DESIGN STATEMENT

2361
FORD CORK LRD

FRD_XX_XX_RP_JFA_AR_P6000
November 2024

Section 32B Meeting Response (LRD 002-24)

Item 7.b - Proposed Centre Park road elevation | Scale 1:2000

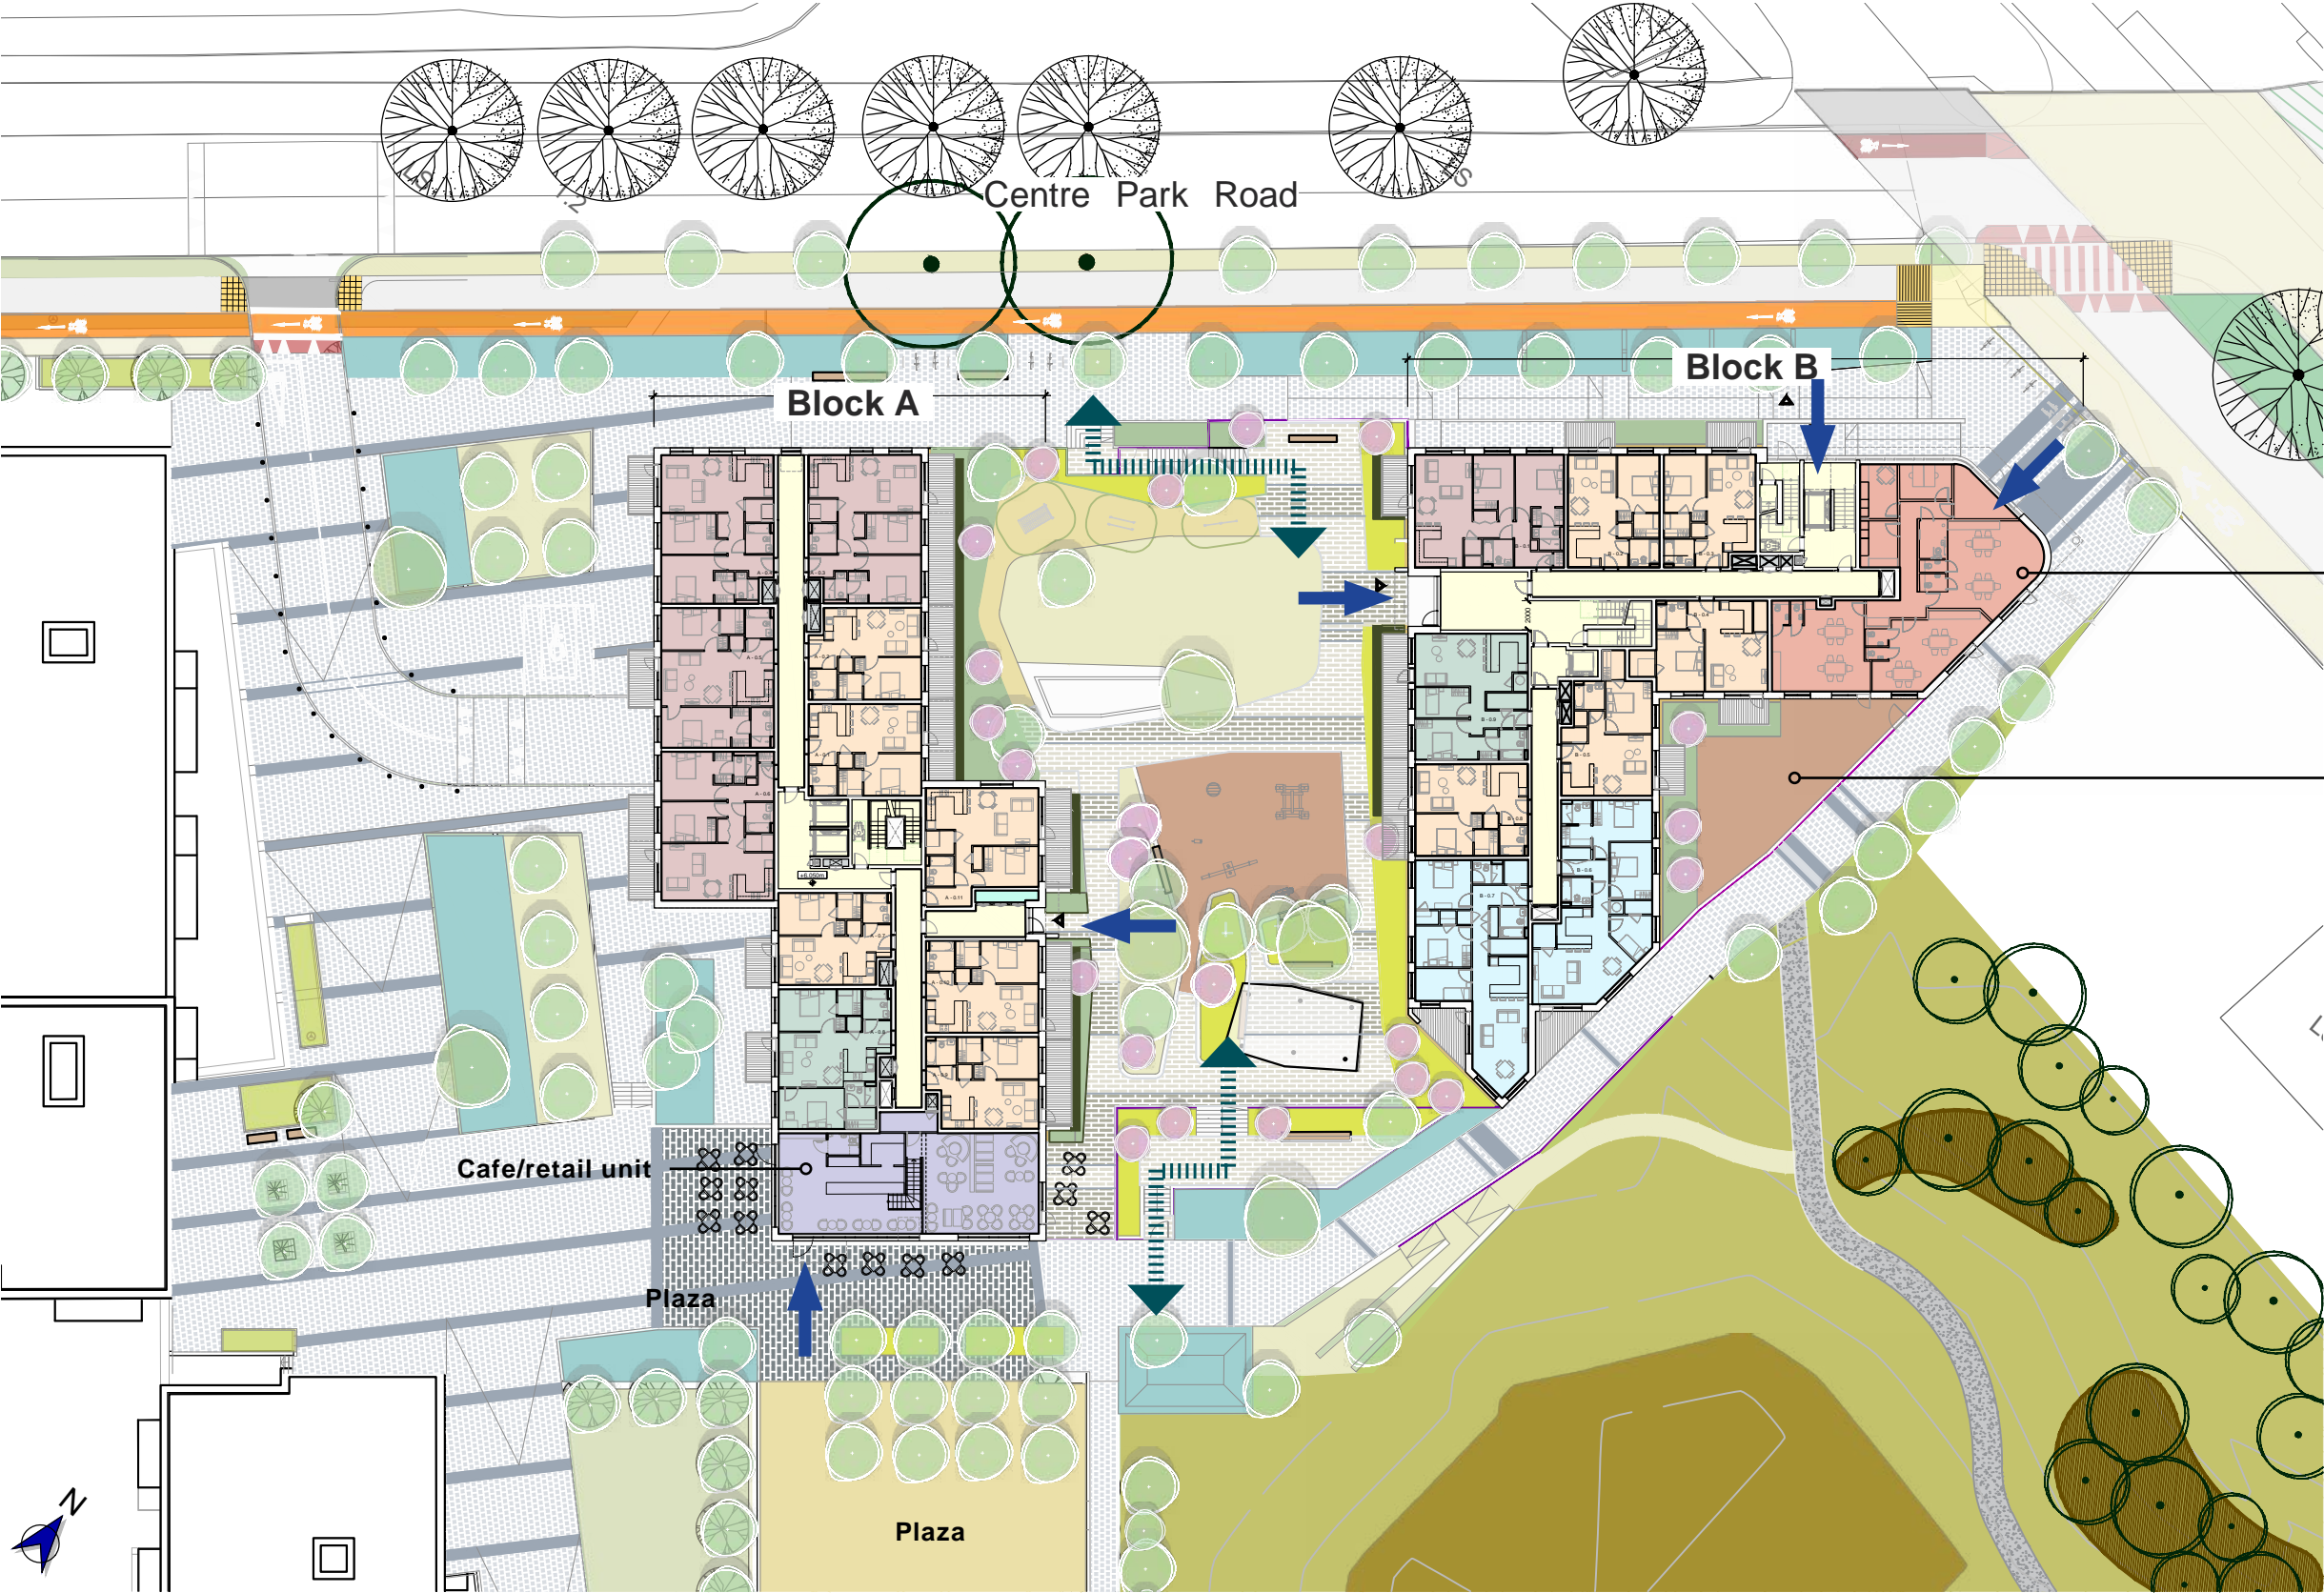
7.b. “The applicant is requested to consider revising and reconfiguring where the scheme interacts with ‘Street C’, with consideration given to re-locating the northmost block closer to the street so as to improve enclosure and more closely follow the rhythm of the blocks established in the approved adjacent SHD scheme. Full details, including sections and 3-D views of same should be included at planning application stage.”

In response to the request for revisions where the scheme interacts with ‘Street C,’ the design for Block A has been updated in accordance with the council’s guidance. The layout of the block has been mirrored, repositioning the northern section closer to Street C in order to improve enclosure and better align with the rhythm of the blocks established in the approved adjacent SHD scheme. Contiguous elevations and sections have been submitted to demonstrate the continuity with the SHD scheme, along with contextual 3D views that illustrate the integration of the revised design within the surrounding development. These materials are provided as part of the planning application.
